**Maine Maritime Academy  
Castine, Maine**

**Pier Upgrades and Waterfront Improvements Project  
March 1, 2024  
ADDENDUM NO. 3**

**STEAM VAULT - NEW WORK**

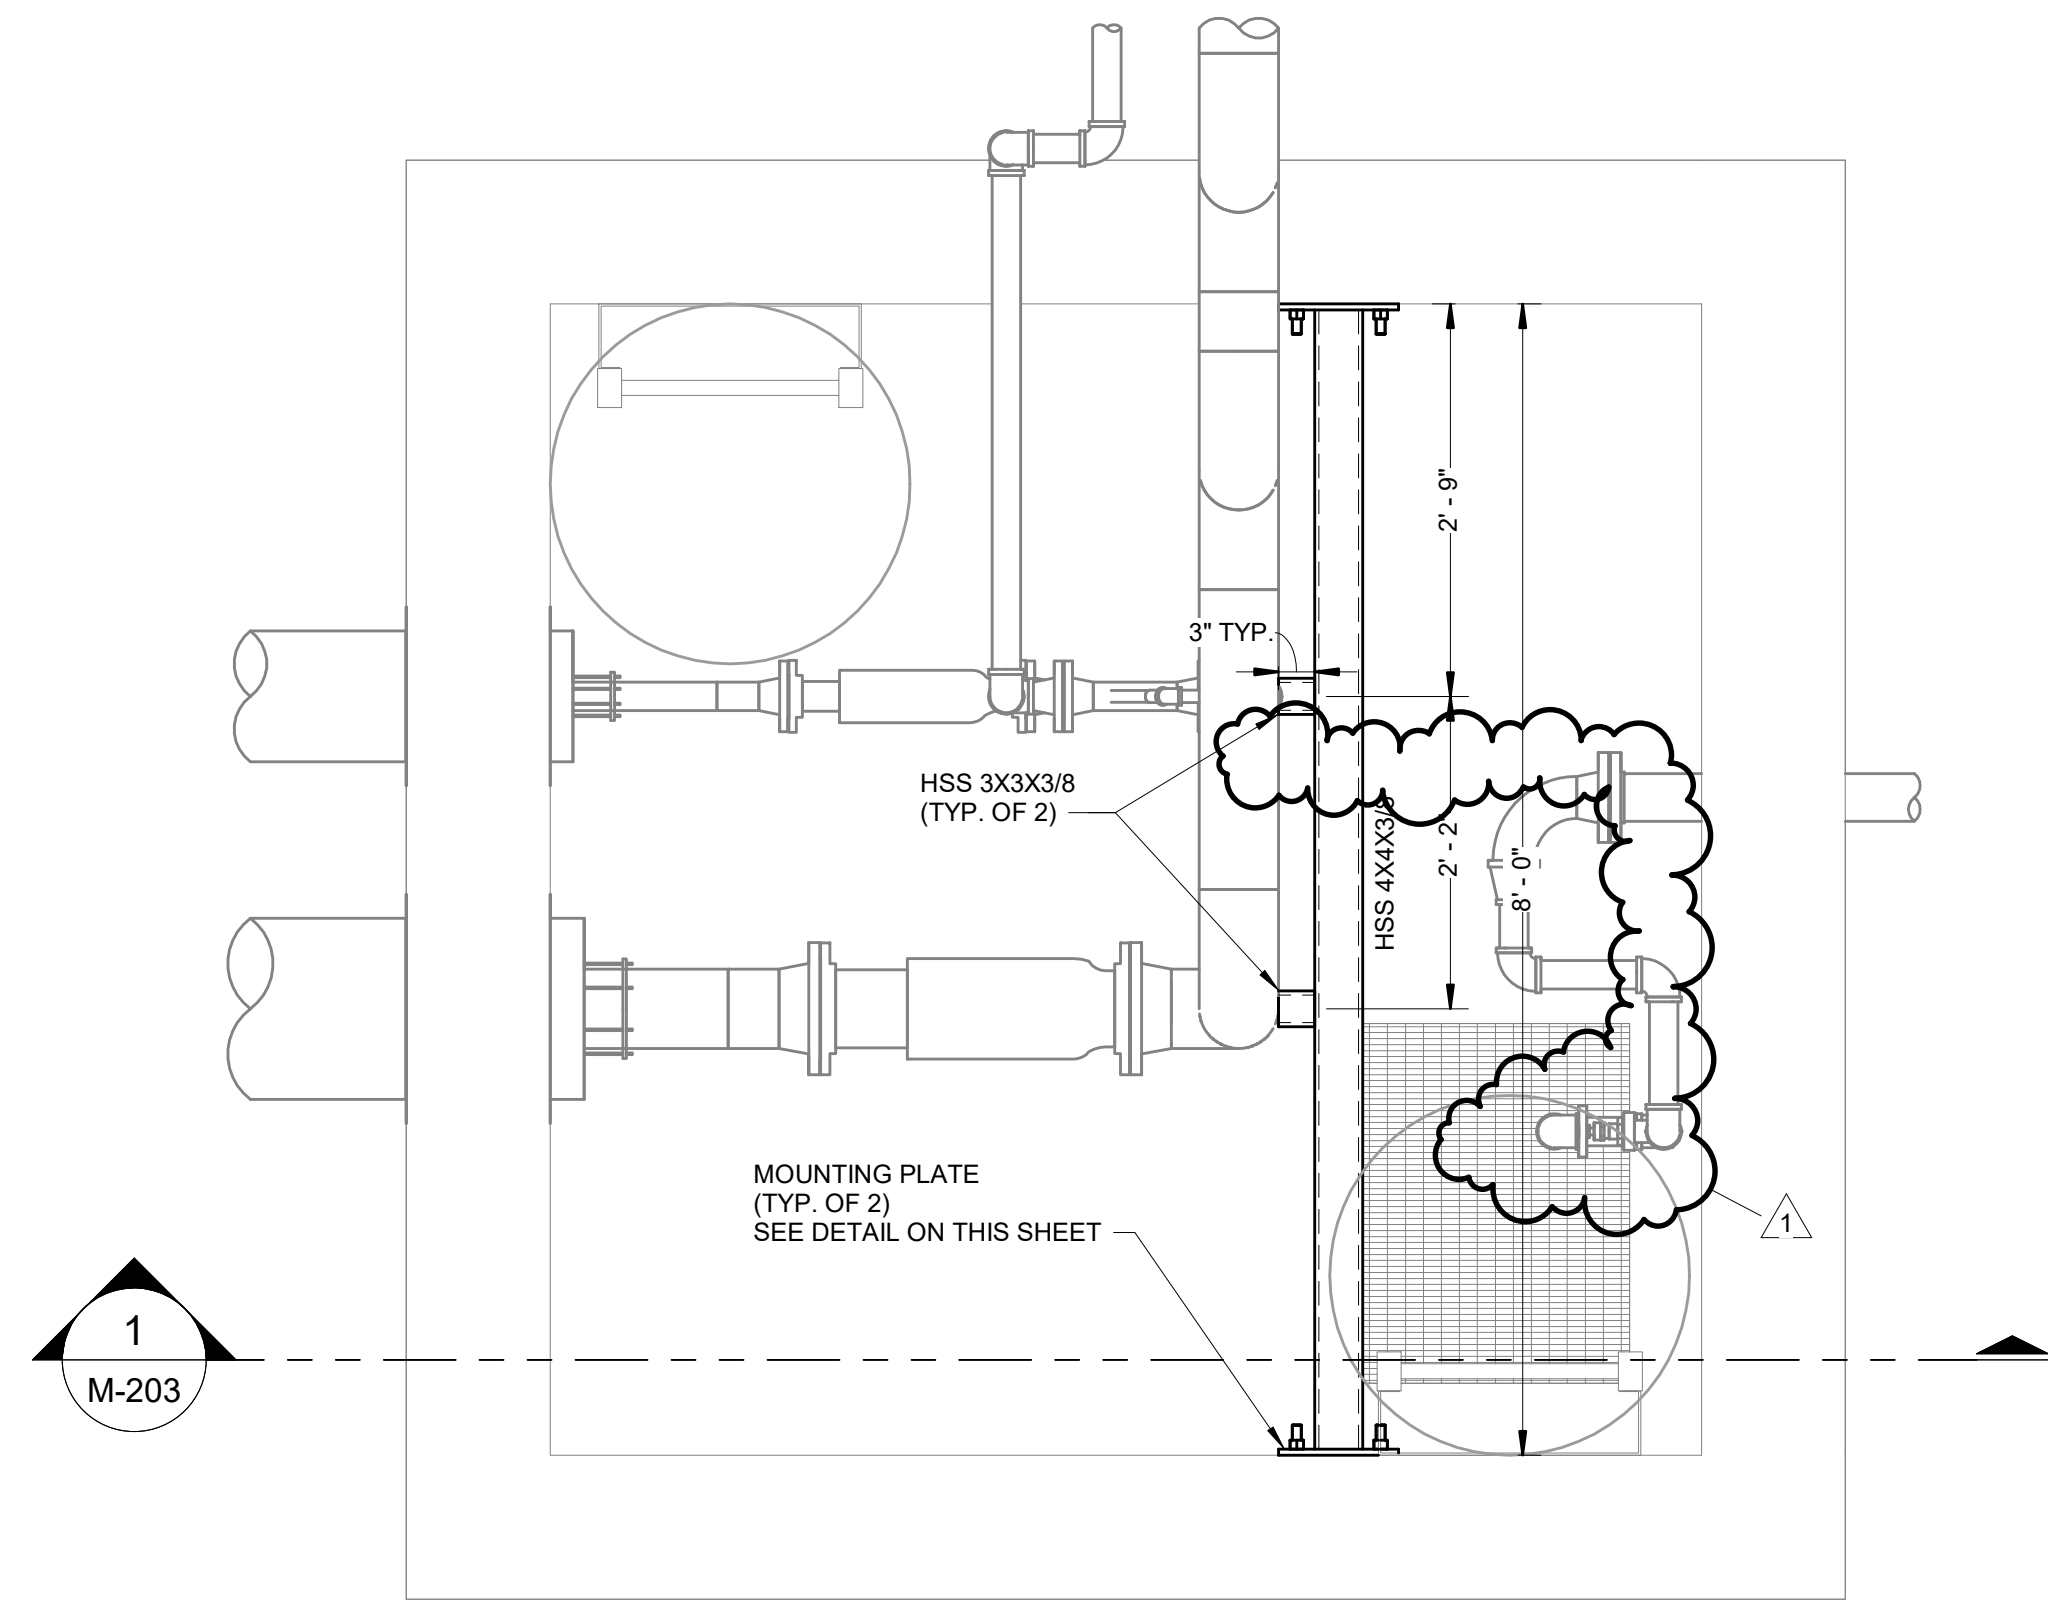
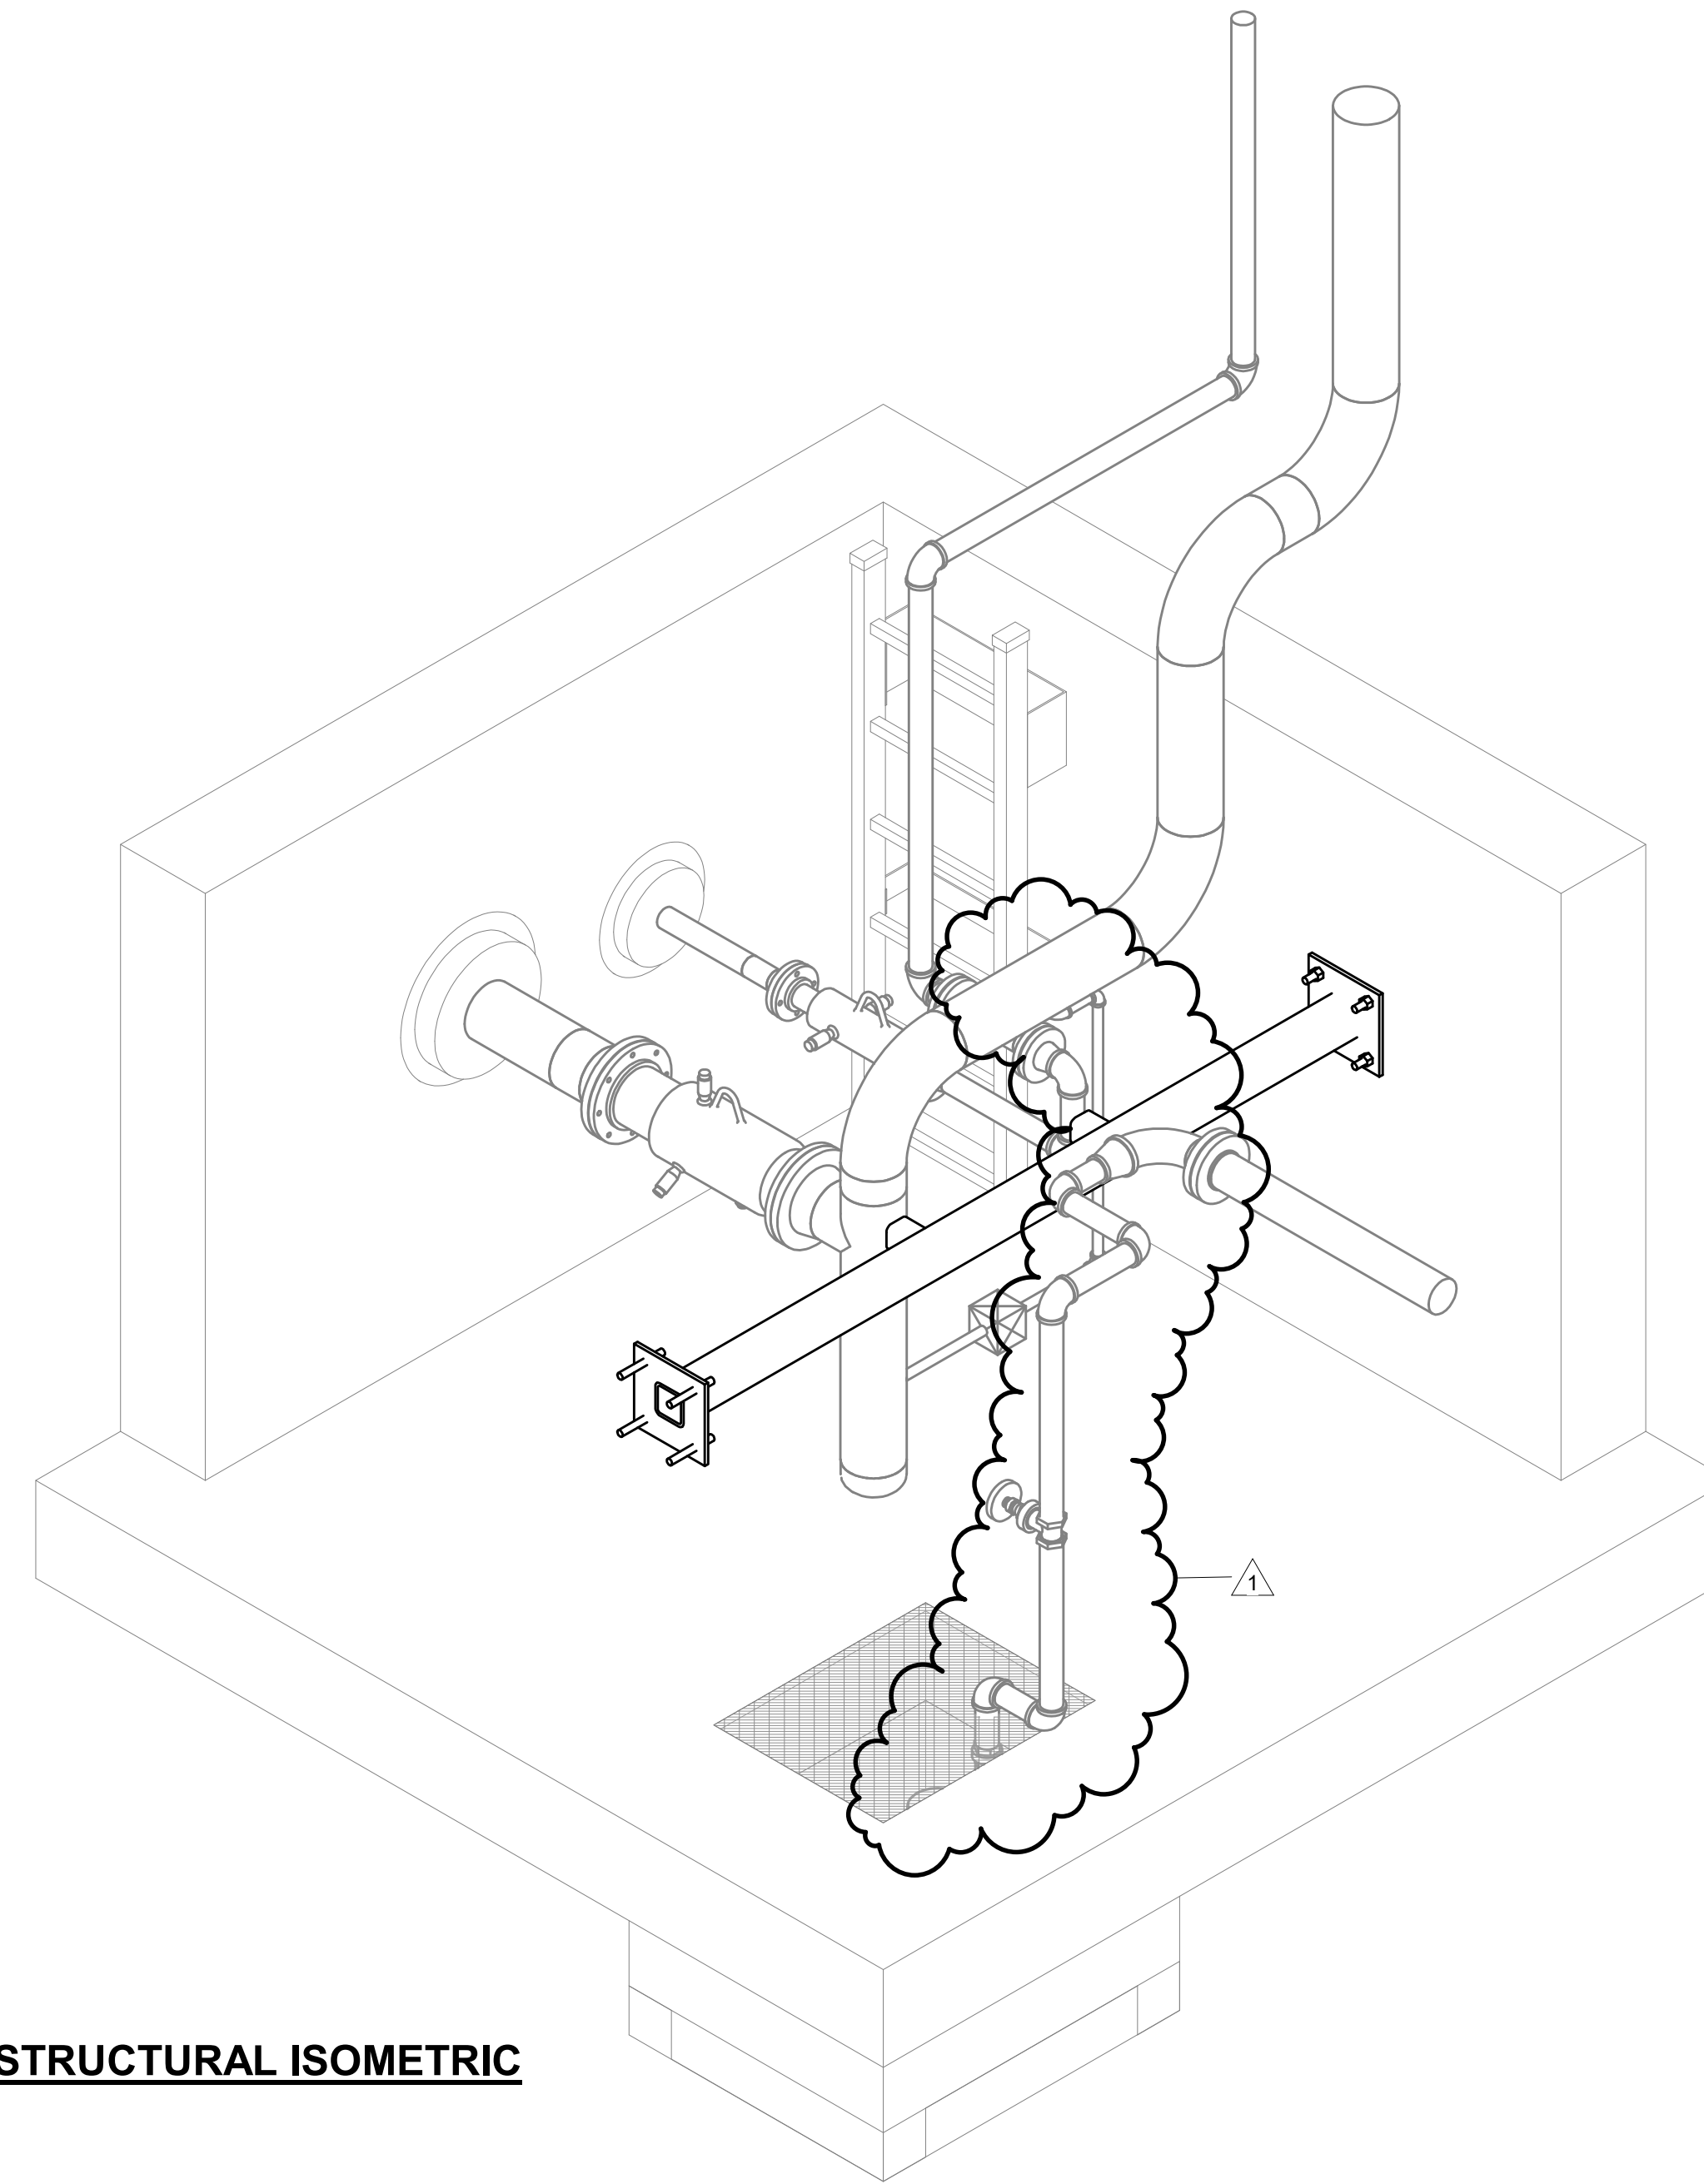
17. M-203 Steam Vault – New Work – Structural
  - a. Changed the sump pump in vault STMH-1 to an electric type, and made the sump pit more shallow.
18. M-204 mechanical Trench Plan – New Work
